SITE PLAN REVIEW AND APPEARANCE BOARD STAFF REPORT

Valhalla Condominiums

Meeting File No.		Application Type			
August 23, 2023	2022-189-SPF-SPR-CLV	Class V Site Plan			
Property Owner		Agent			
SIR II Development, LLC		Josh Nichols of Schmidt Nichols Landscape Architecture and Urban Planning

Consideration of a Class V Site Plan, Landscape Plan, and Architectural Elevations for the construction of a four-story, mixed-use development, including ground floor non-restaurant commercial space and seven residential units, located at 235 SE 5th Avenue.

ARCHITECTURAL SITE PLAN

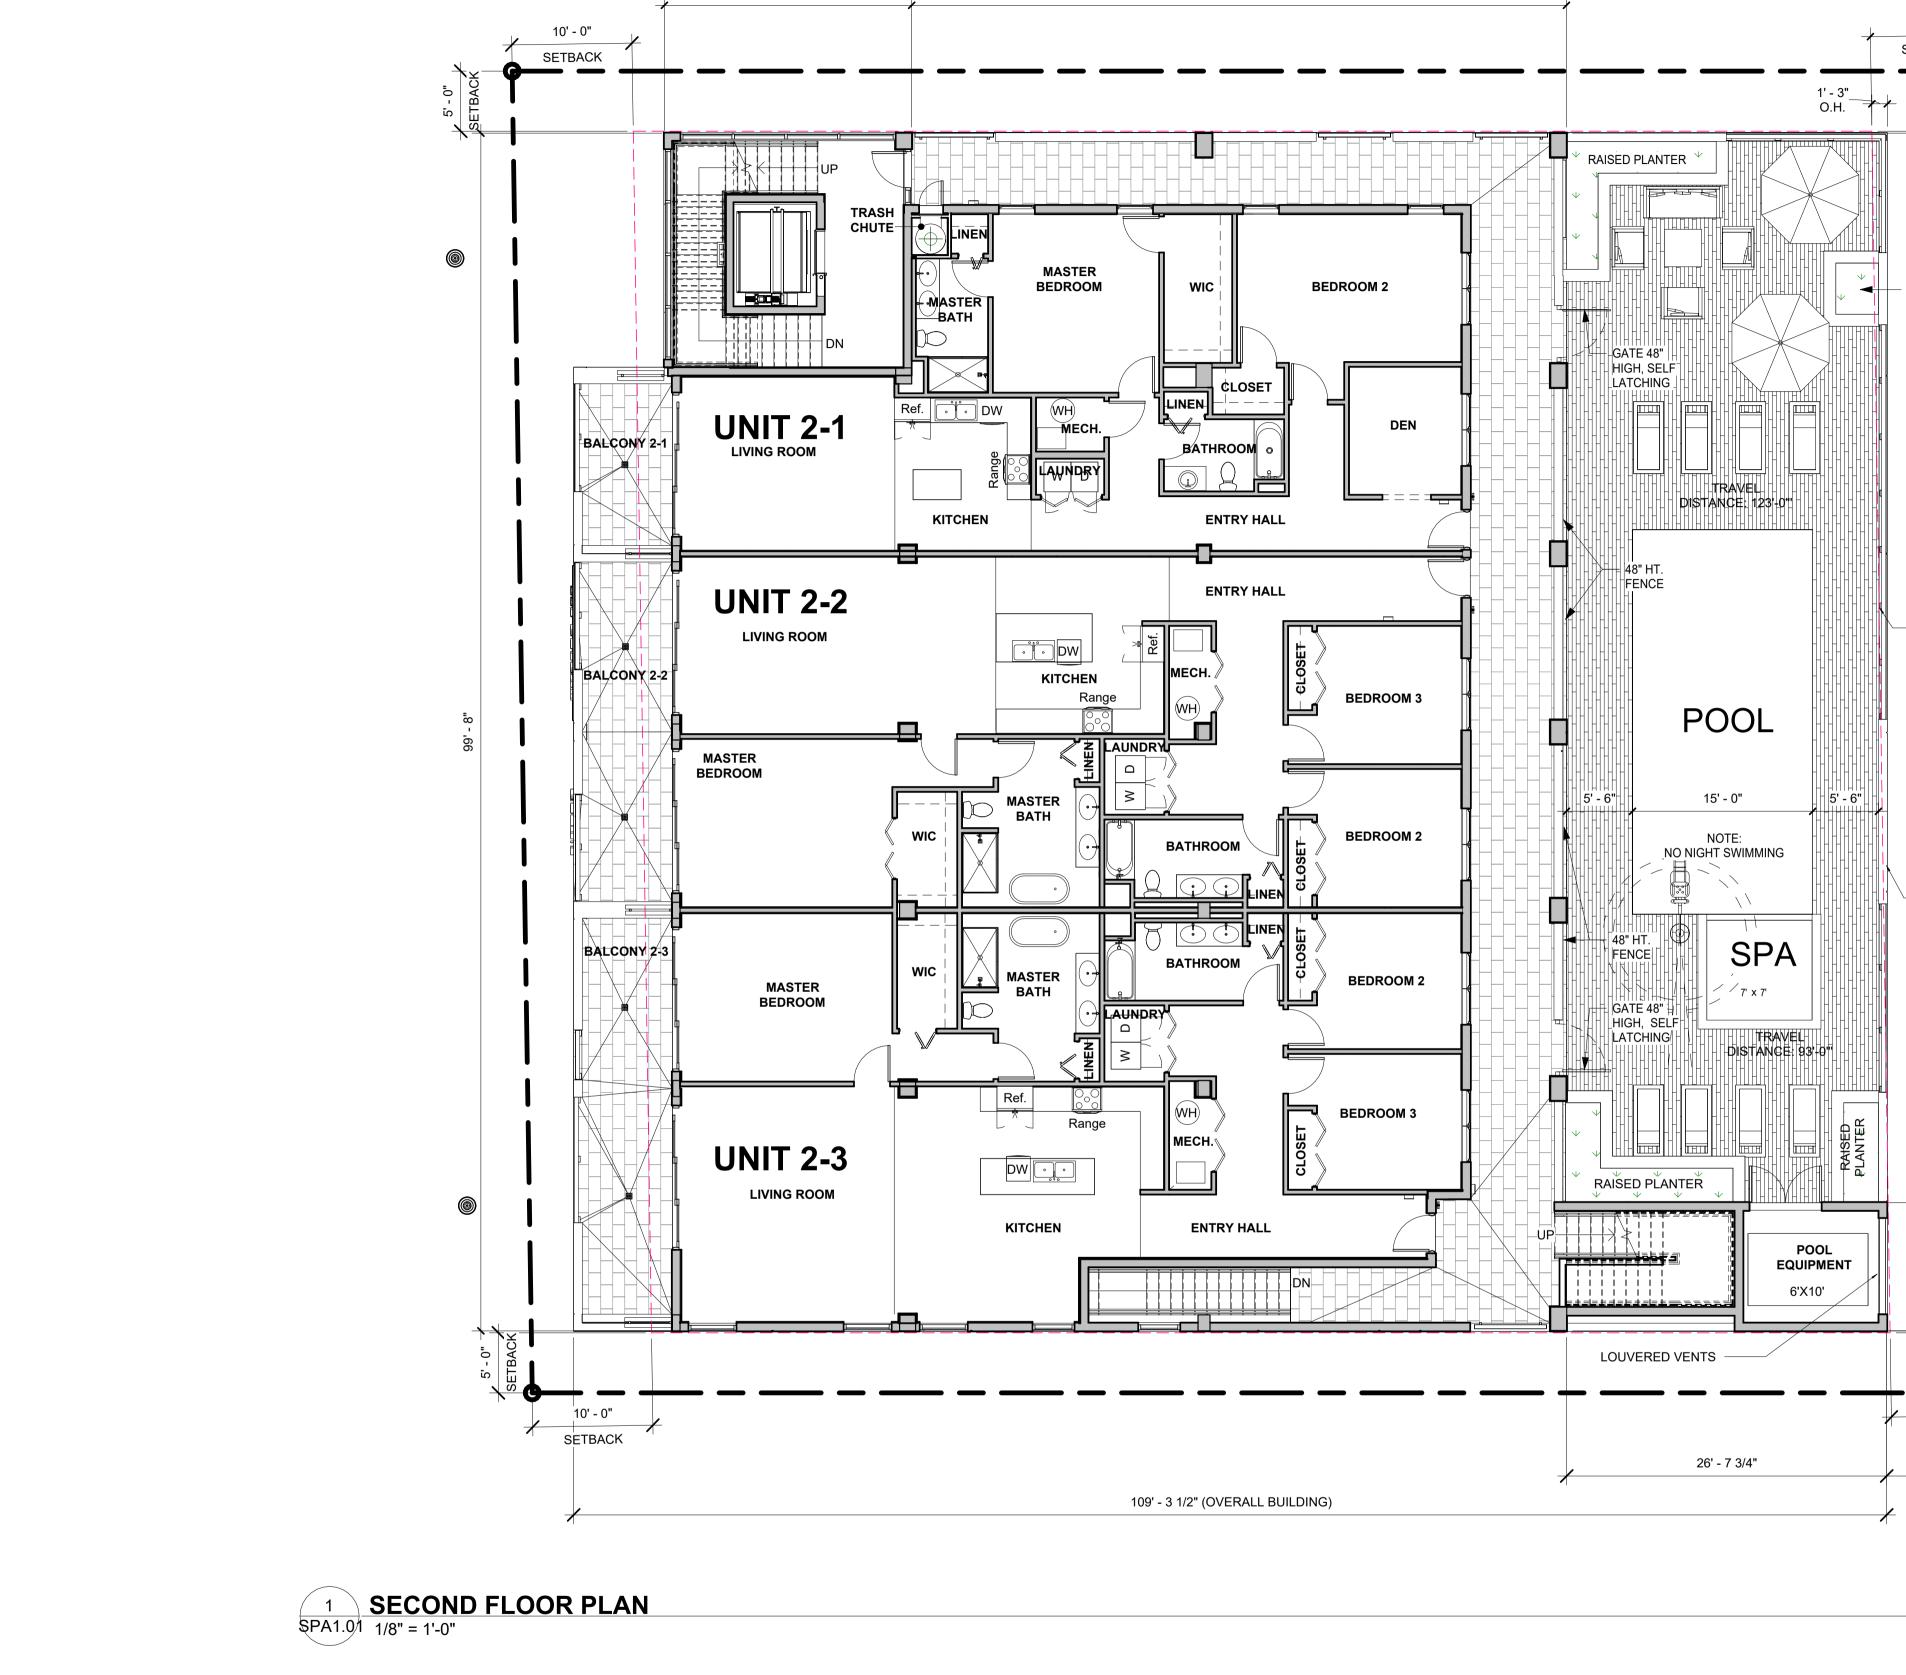
- 1. Ensure that sheet SP-1 and SPA1.00 are consistent, specifically regarding the labeling of the electric vehicle (EV) parking spaces.
- 2. Ensure that the streetscape diagram on sheet SPA1.00 reflects the same dimensions on the first floor plan on sheet SPA1.00.
- 3. Add a note to Sheet SPA1.08 and provide documentation to demonstrate the windows used to meet the minimum opening requirements meet the definition of transparent as outlined in LDR Section 4.4.13(F)(5)(a), meaning non-solar, non-mirrored glass with a light transmission reduction of no more than 20 percent.

EXTERIOR σ _{ELEVATIONS}

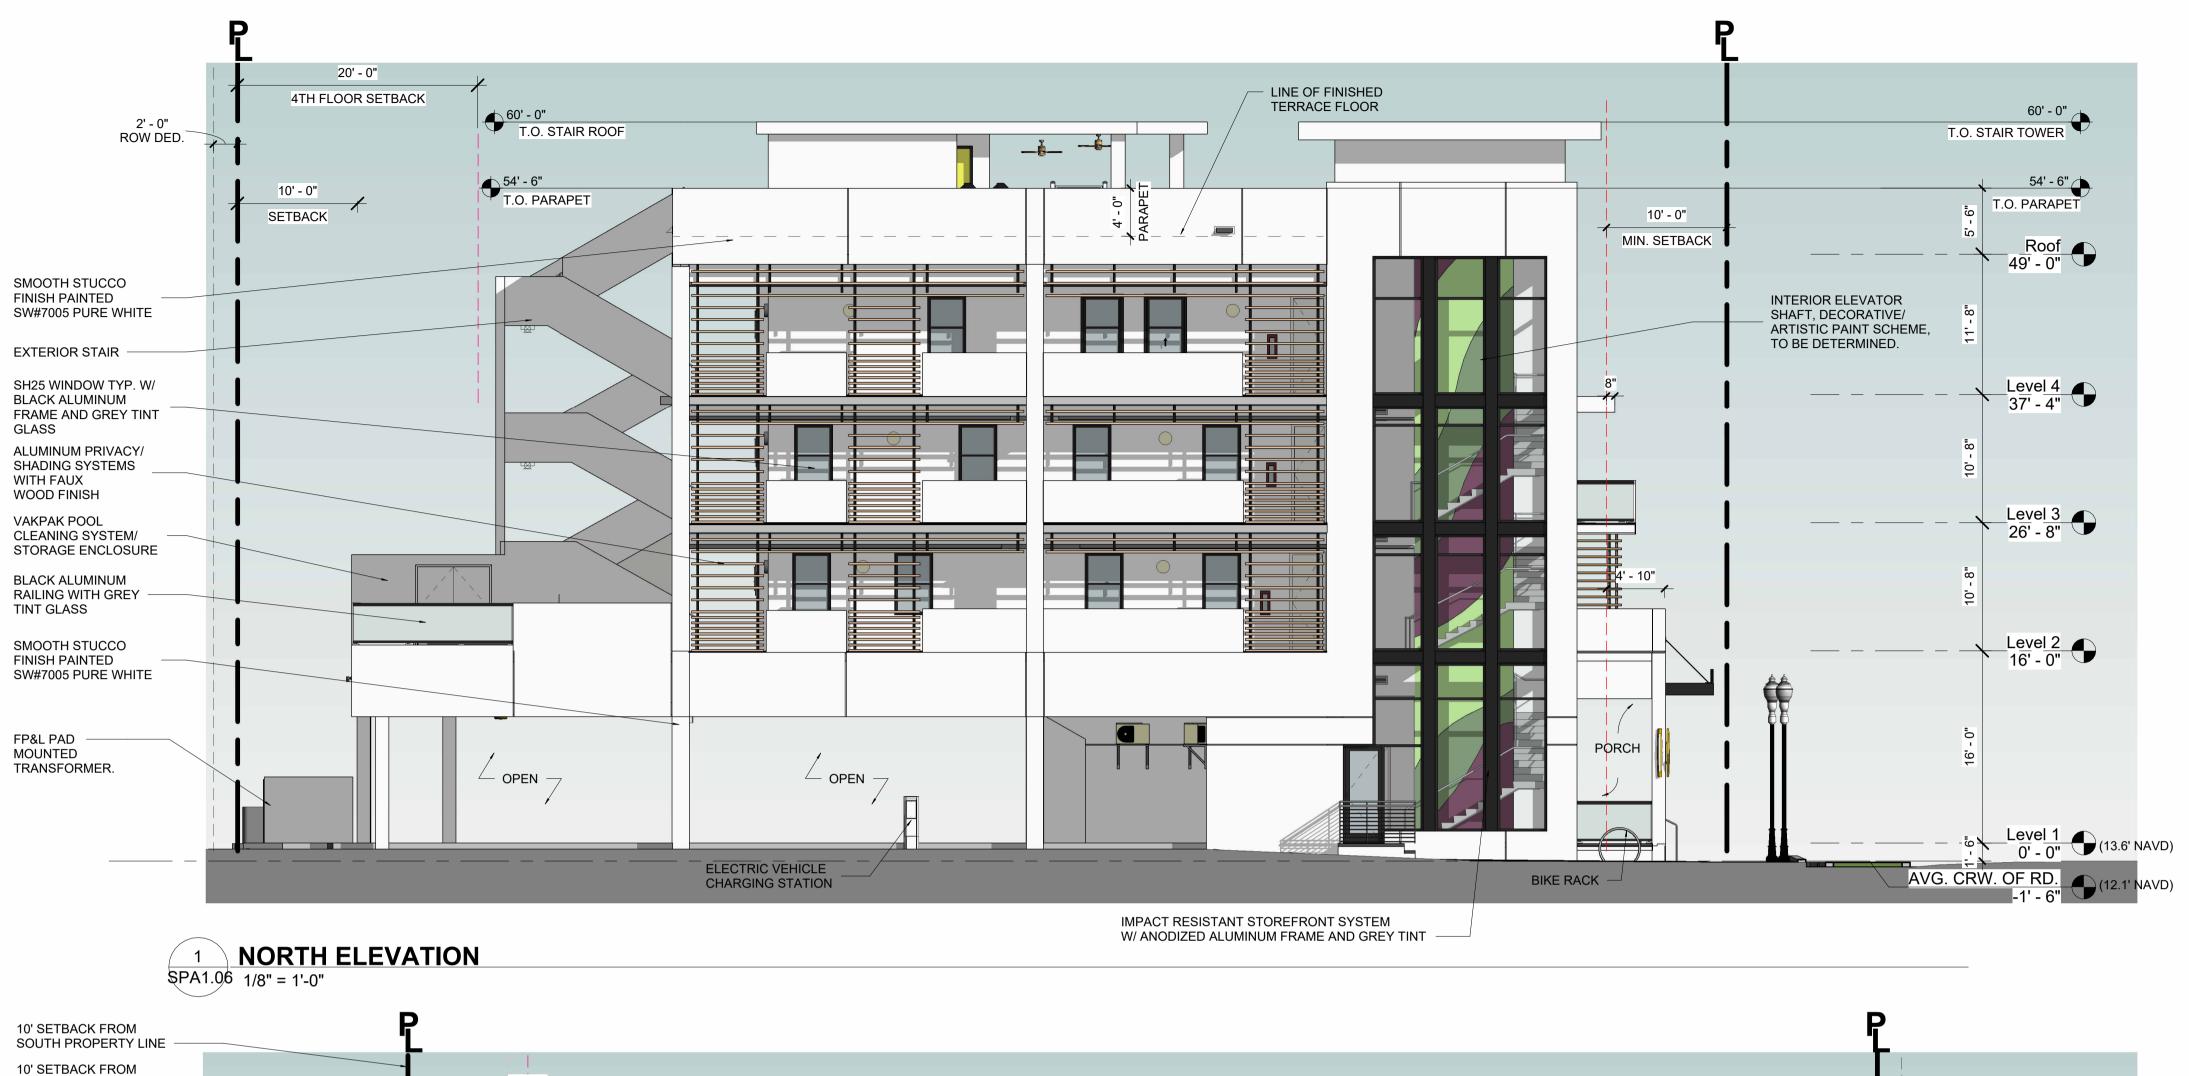
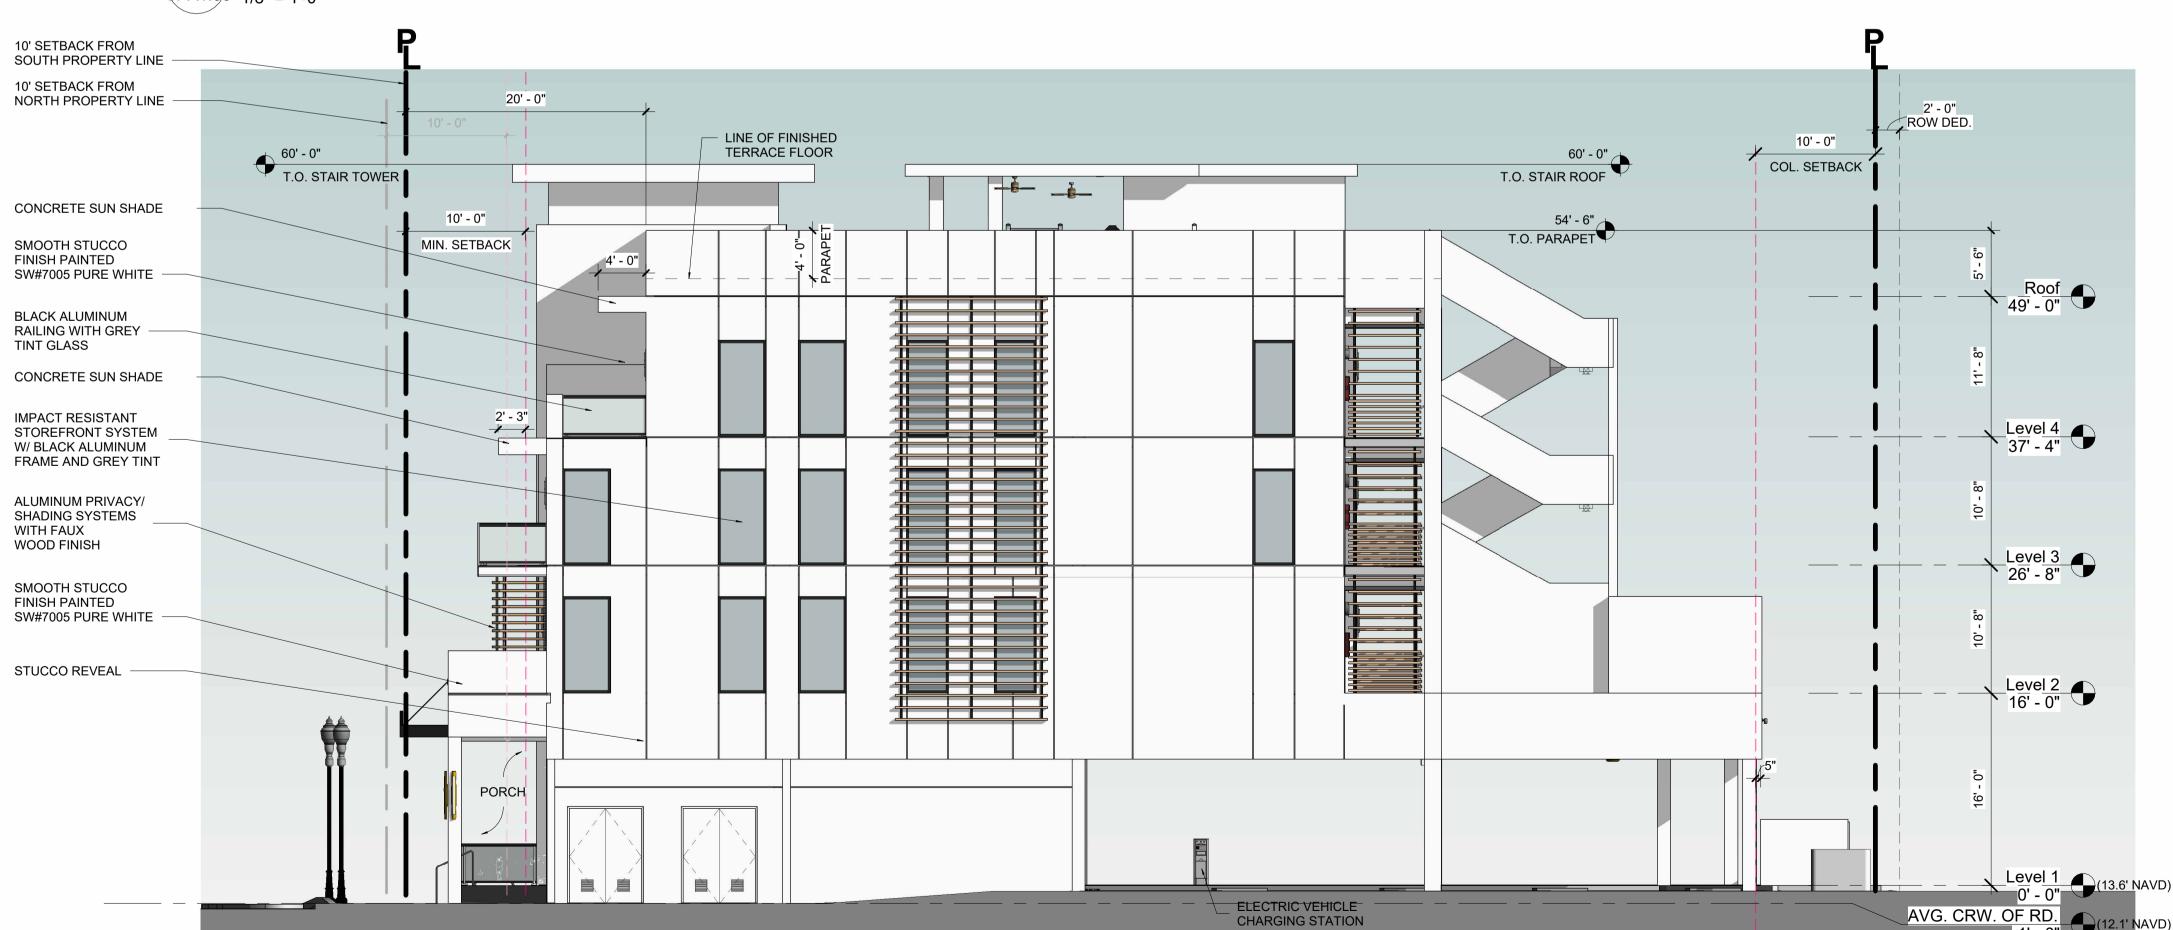
Based on the modifications proposed after the June 28, 2023, SPRAB meeting, the Board should consider keeping the dimensions of the frames similar to the previous proposal, as the color and thickness of the frames on the tower and second through fourth story add weight to the building and do not necessarily help soften the stark forms of the Masonry Modern architecture.
